DFCM Addendum No.1

Date: July 20, 2023
To: Bidding Contractors
From: Carl Francis-DFCM Project Manager
Reference: Main Campus Meat Lab Freezer Floor Repairs
 DFCM Project 23462210

date: 6/15/2023
project: BTech Meat Services
Freezer Floor Replacement
by: Stephen Williams
subject: Addendum 1

1/2" = 1'-0" WALK-IN FREEZER

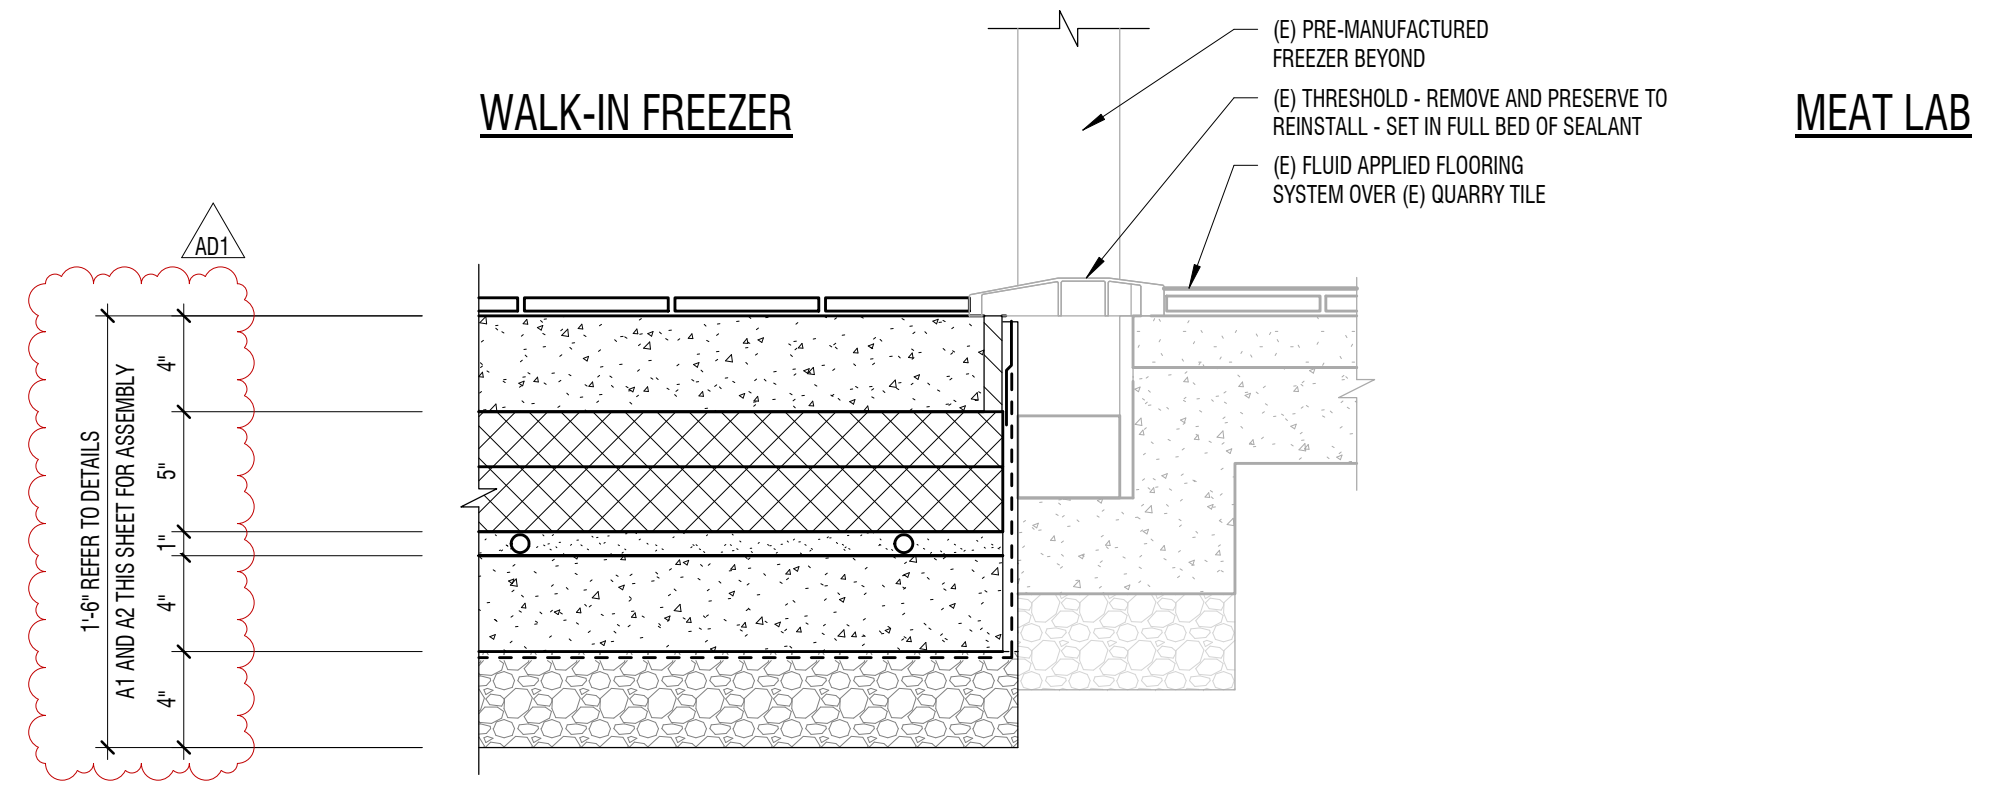
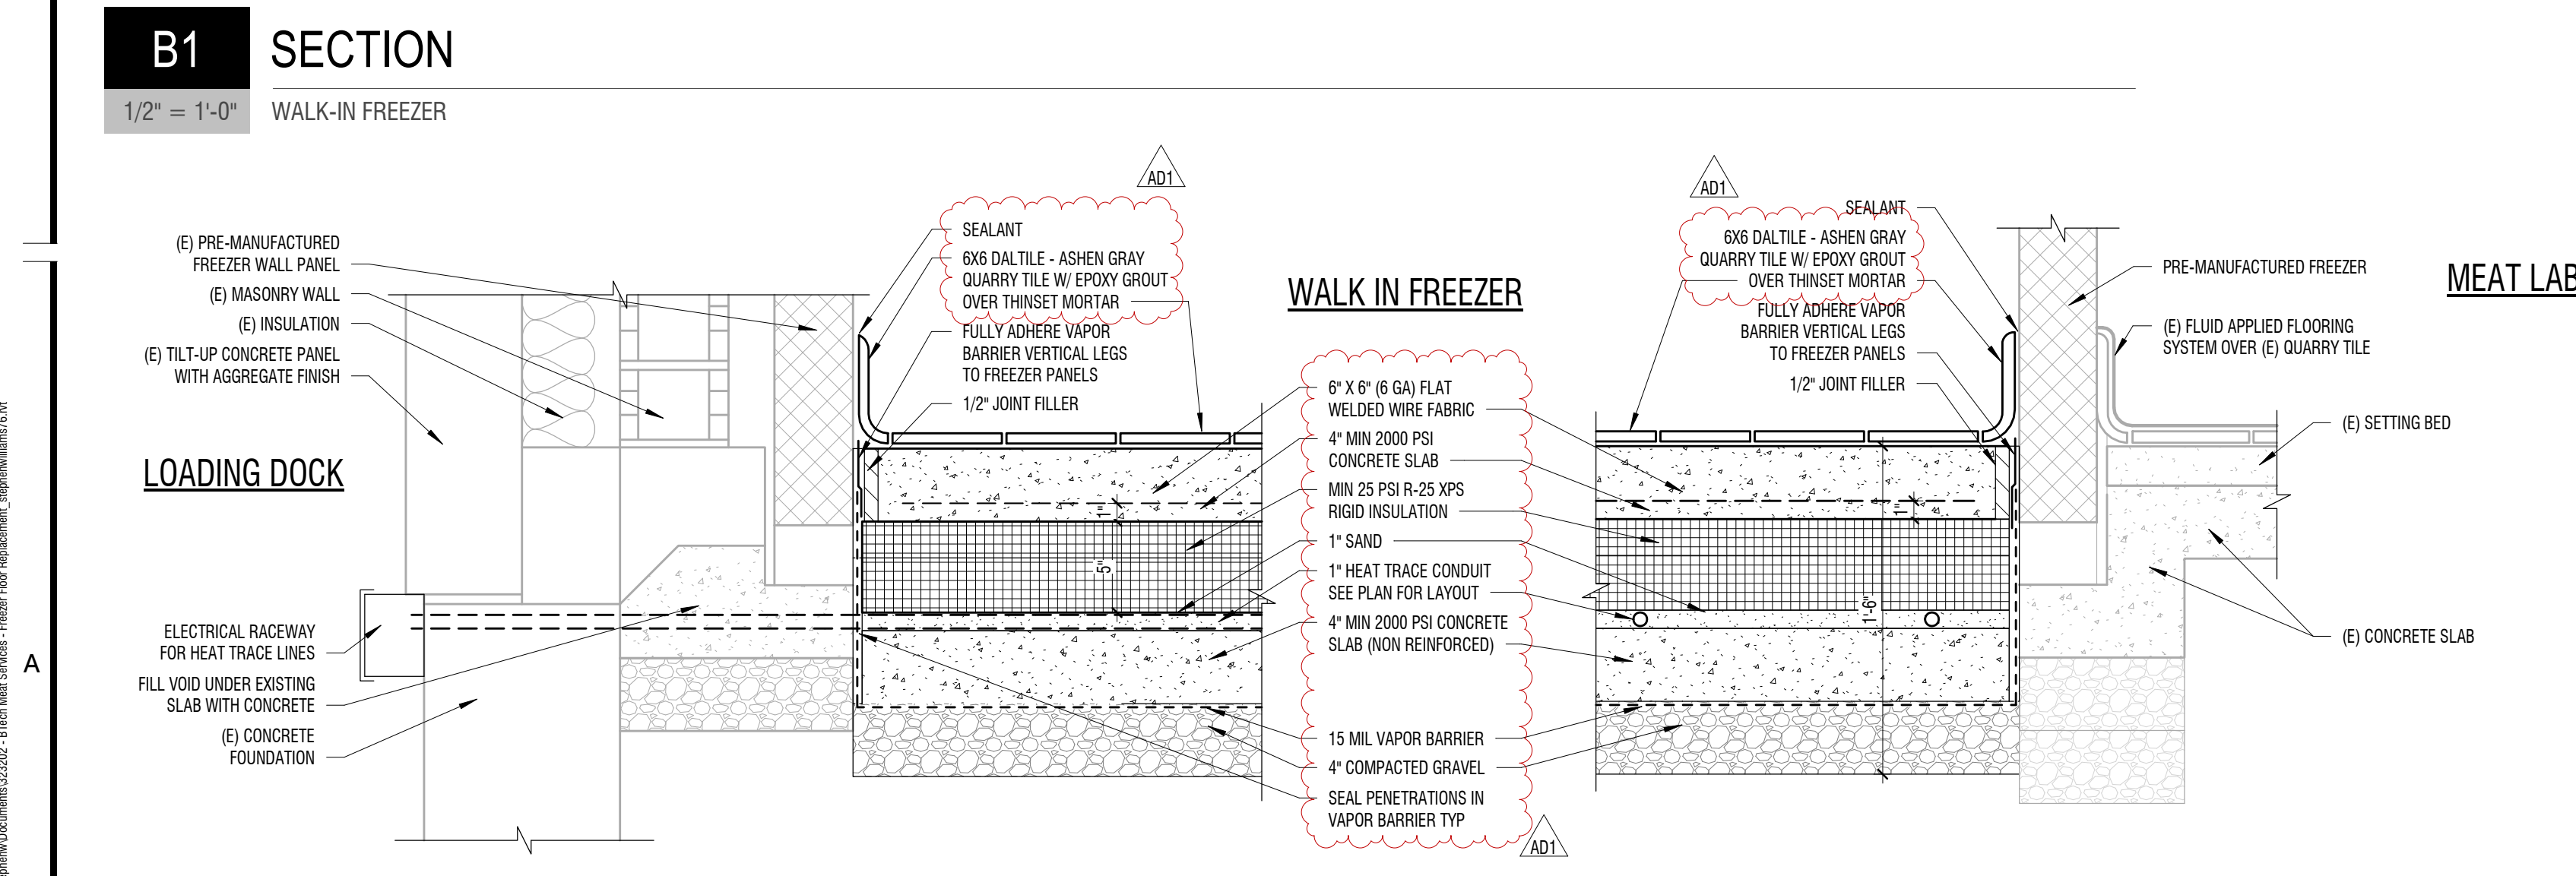
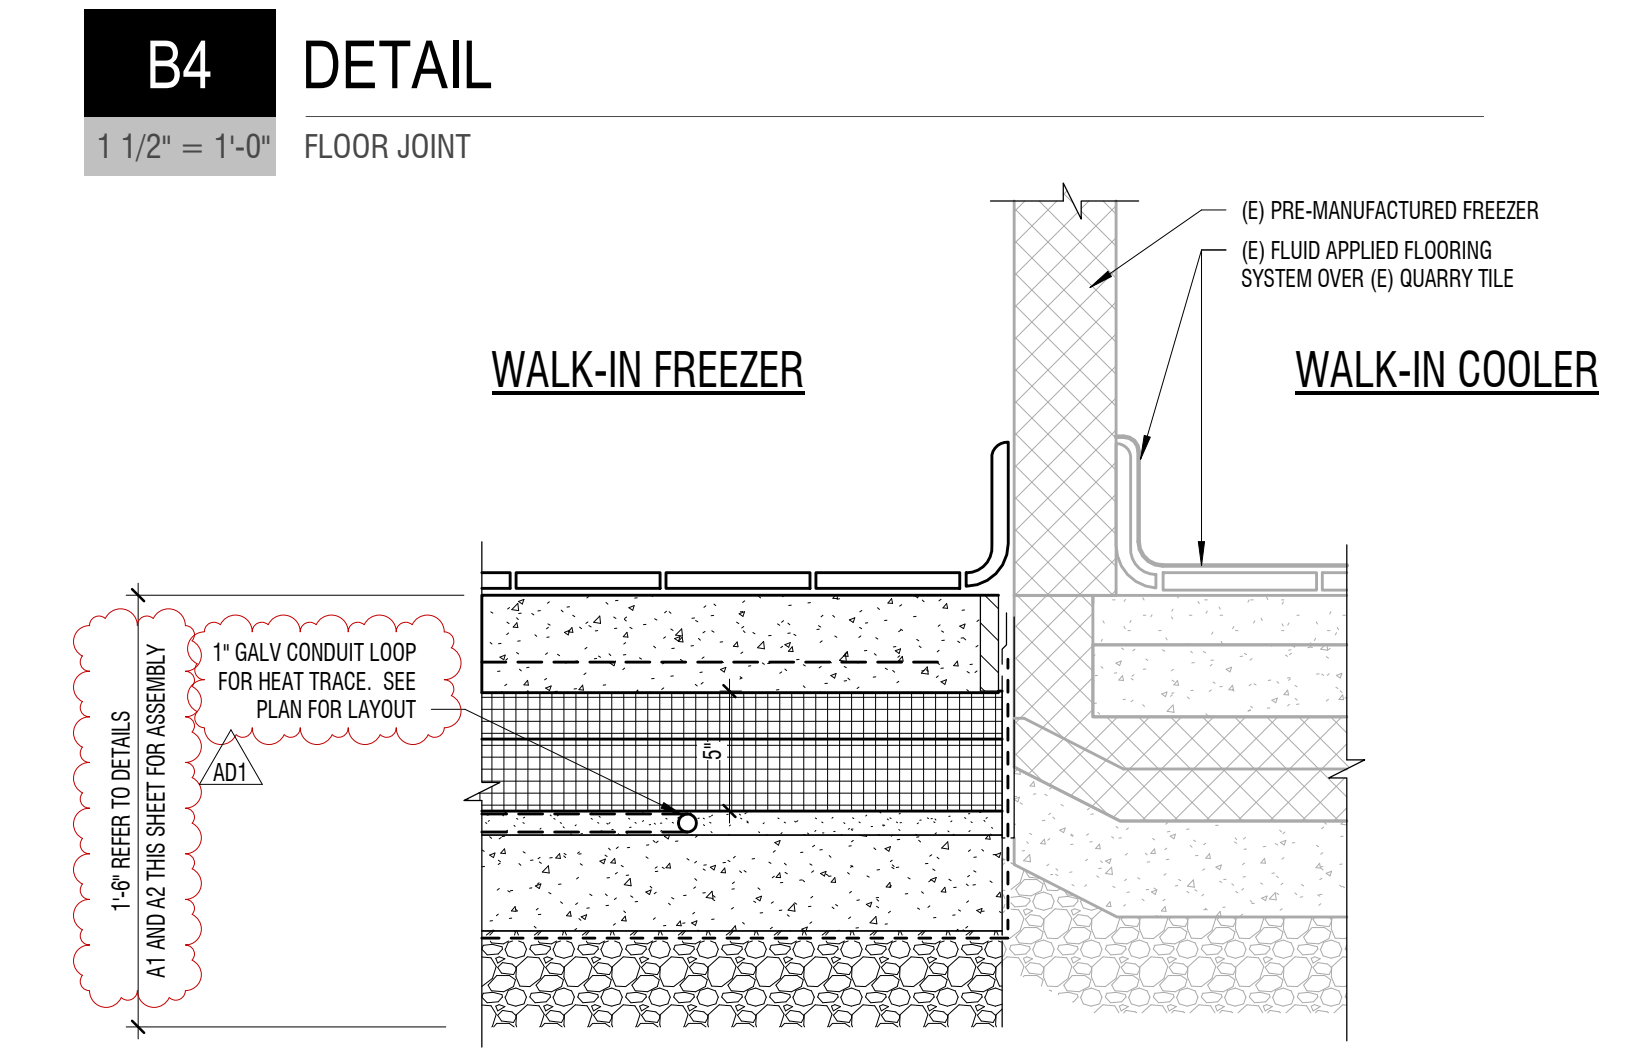
AD1.0.2 A-101 FLOOR PLAN, DEMOLITION PLAN & DETAILS

1. Clarified floor components
 - a. PSI strength for concrete added
 - b. Specified tile to be installed with pattern layout
 - c. Added epoxy grout requirement
 - d. Added Welded Wire Fabric Mesh requirement to notes including size and placement.
 - e. Adjusted conduit sizing to 1" from ¾" to align with electrical requirement.
 - f. Specified MIL thickness of vapor barrier.
